# Index 550-013 Bridge Fencing on a Barrier (Over Railroad)

## **COMMENTARY**

#### **COMMENTS AND RESPONSES**

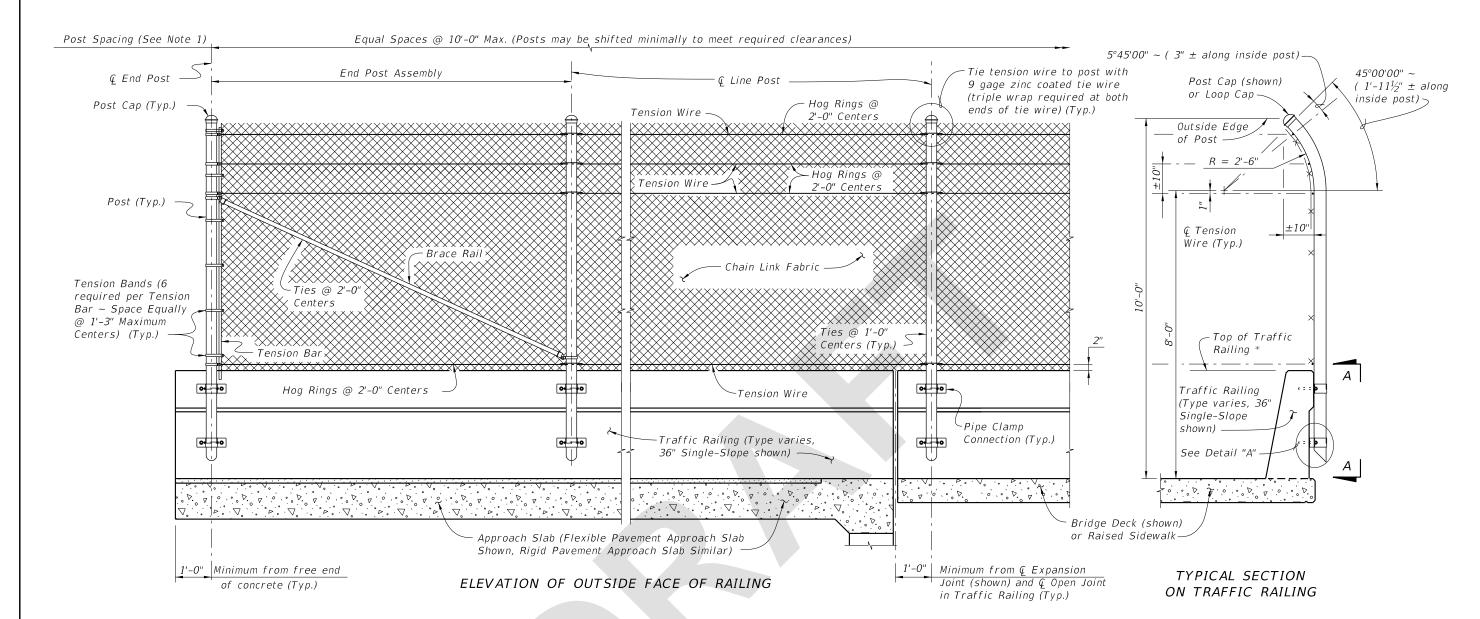
**COMMENT:** Please reconsider the RENAMING of these Indexes.....to avoid confusion.

Index 550-010 (which is not being revised) shows vertical bridge fencing on Traffic Railing Barrier and on Concrete Parapet.

The revisions propose to RENAME:

Index 550-011 to "Bridge Fencing on Parapet" Index 550-103 to "Bridge Fencing on Barrier"

Such that it is confusing how these Indexes are different from 550-010...or are meant to supplement 550-010.

**RESPONSE:** Agreed. Will rename 550-011 to "Bridge Fencing on a Parapet (Curved Top)" and 550-013 "Bridge Fencing on a Barrier (Curved Top)" in order to distinguish them from the Vertical version. The term "pathway" was used as a more general term to encompass both sidewalks and shared use paths that may be used with this Standard. We did not want to limit to either a sidewalk or shared use path.

CHANGE MADE TO INDEX: Yes; 550-013 was renamed.
